**APPLICATION TO THE ZONING BOARD OF ADJUSTMENT**

Applicant: Undici Due, LLC

DRAWING TITLE:  
**UNDICI RUMSON - SIDEWALK FURNITURE PLAN**

**Re: Undici Due, LLC  
11 West River Road (CR 10); Block 29, Lot 4, GB Zone  
Minor Site Plan  
Completeness Review, Engineering Review, and Fee Determination**

**1** SIDEWALK FURNITURE PLAN  
SCALE: 1/16" = 1'-0"

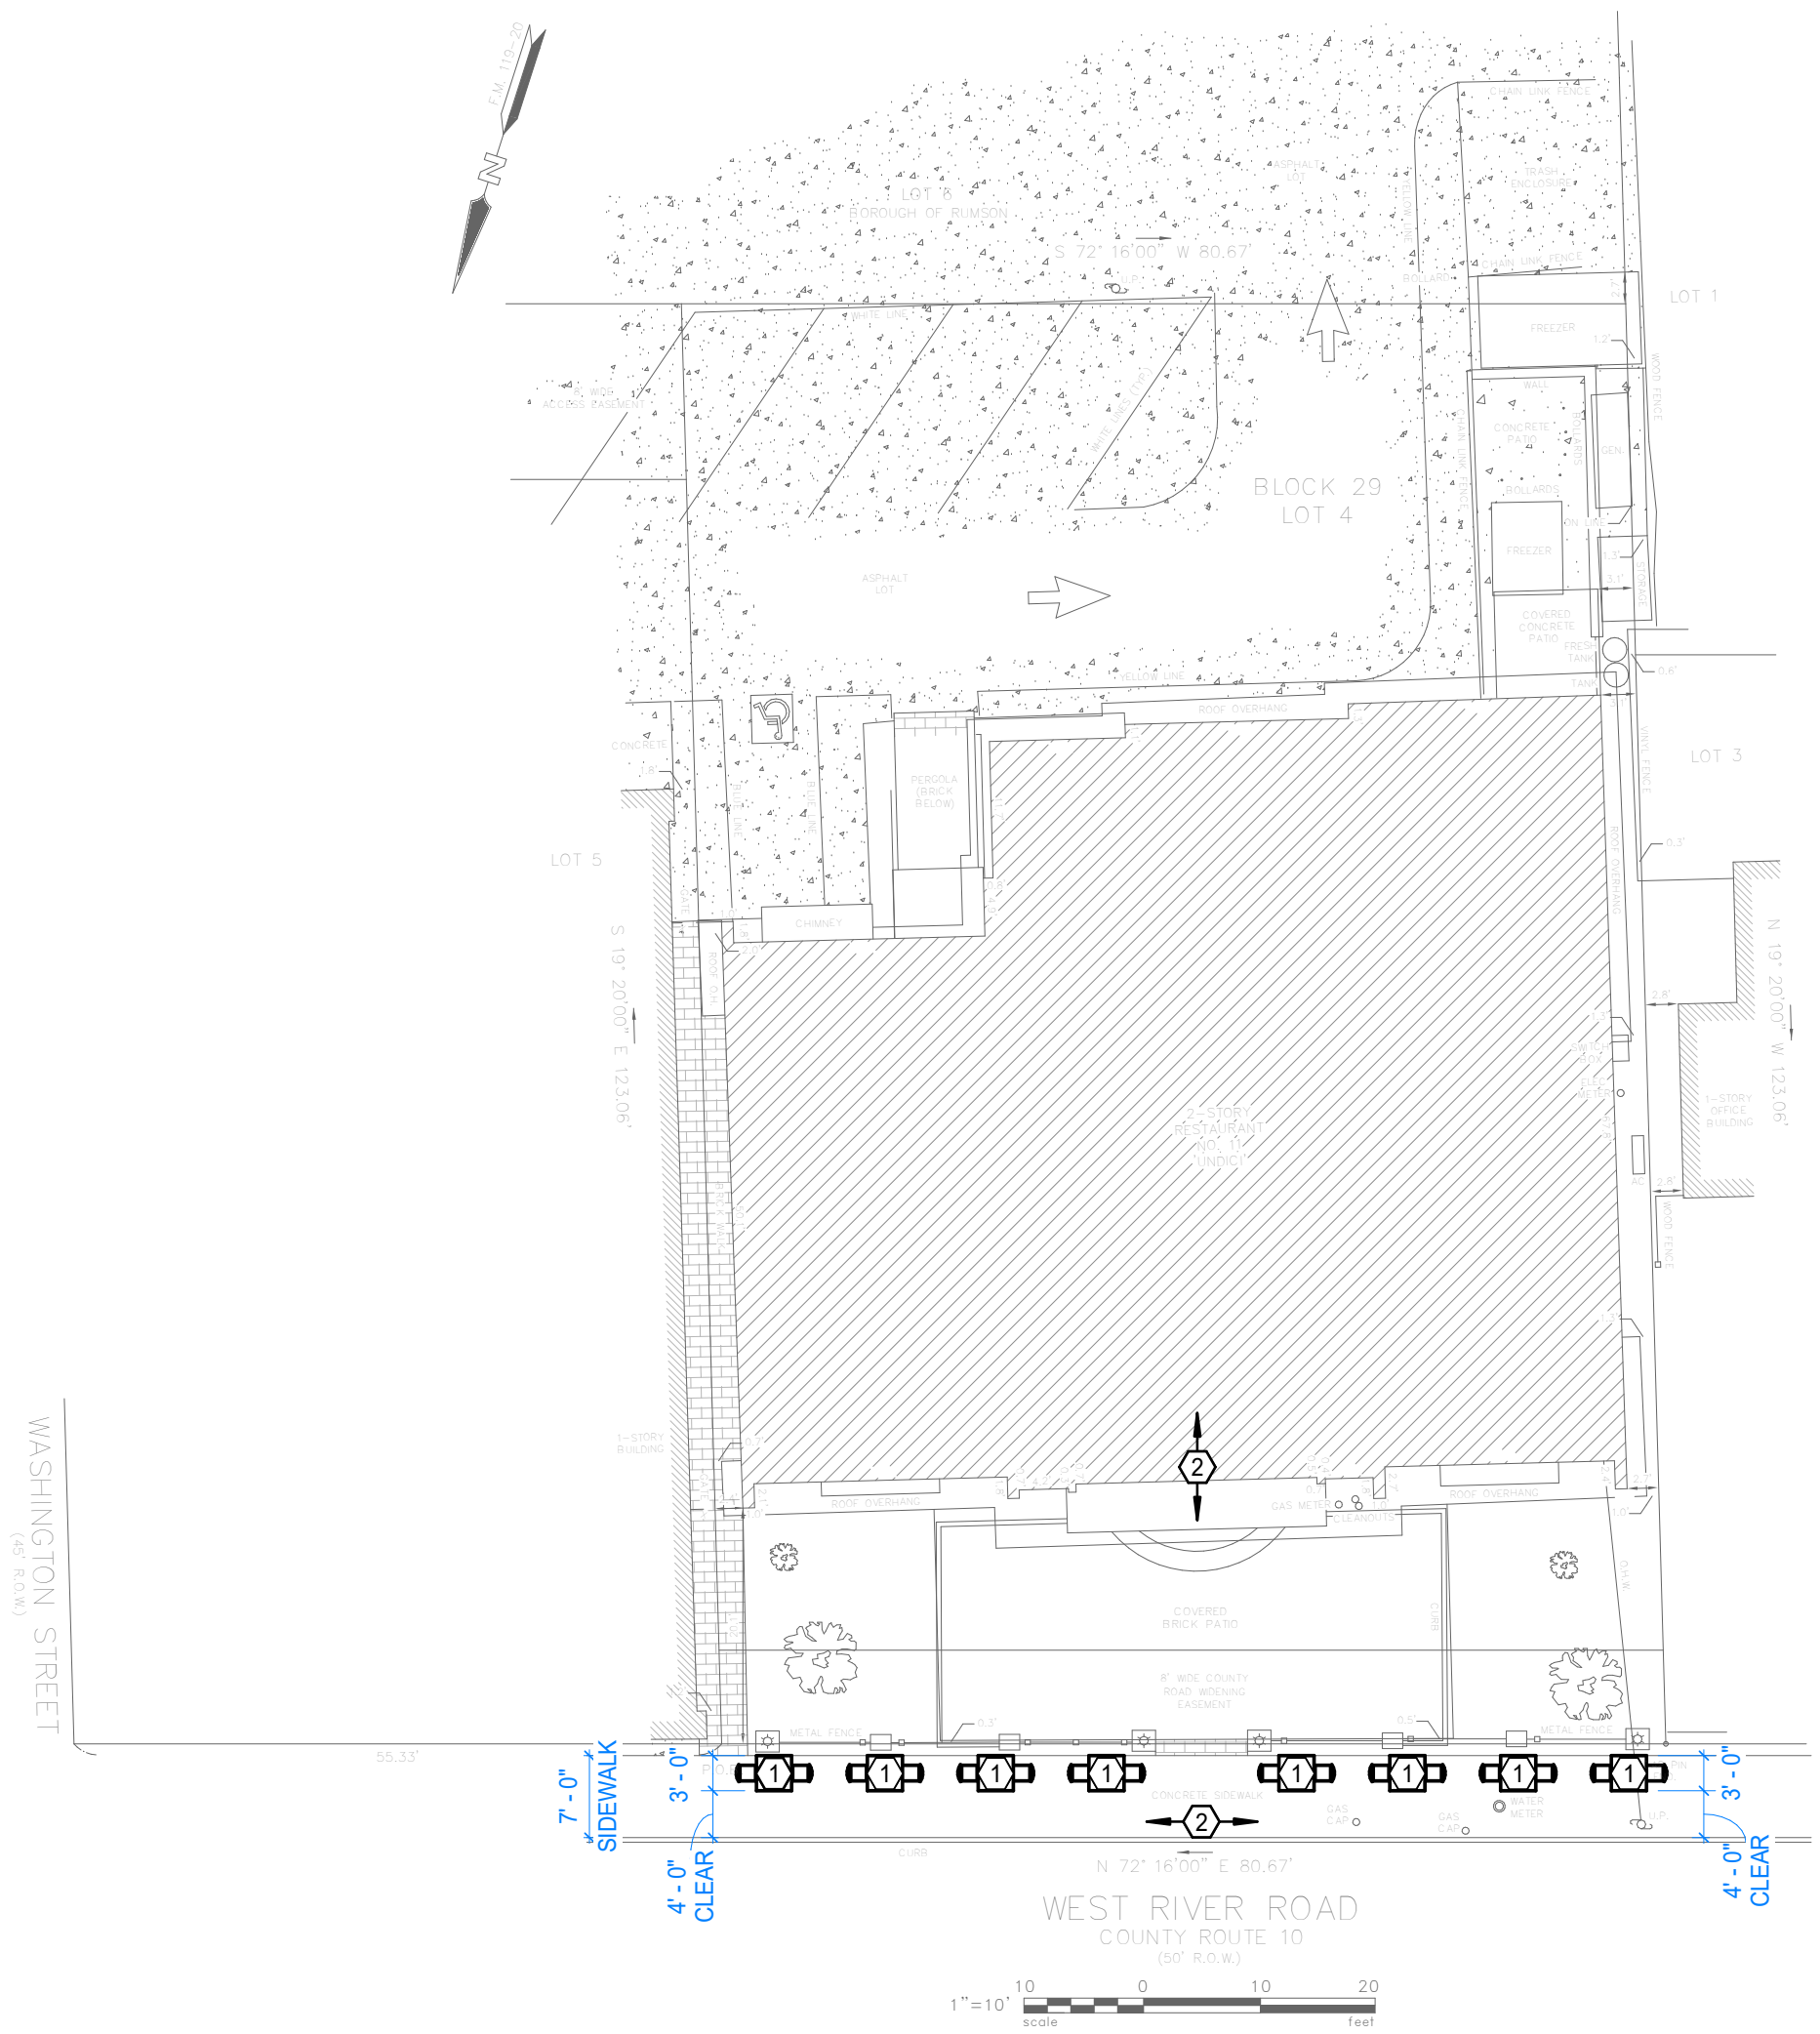
- iv. Ordinance §22-7.37.b requires outdoor cafés to be setback at least 50% of the required setbacks noted in §22-6.10c. Therefore, the outdoor café requires a setback of 17.5 feet to front/side/rear lot lines and a setback of 25 to the street line. No setback is provided from the lot lines as the area is proposed outside the property. A setback of 4.5 feet is provided to the street line.

- 2.1 Per the Public Right-of-Way Access Guidelines (PROWAG), a minimum 4-foot-wide continuous clear width is required. The plans indicate the sidewalk is 7 feet wide, the proposed tables are 3 feet wide, and a 4-foot-wide clear width will be maintained. However, an existing utility pole conflicts with this requirement and provides approximately 2 - 2.5 feet of clearance between the utility pole and the seating area. The seating area shall be relocated/reduced as necessary to provide a minimum 4-foot-wide clear width at all points along the property frontage, including around the utility pole.
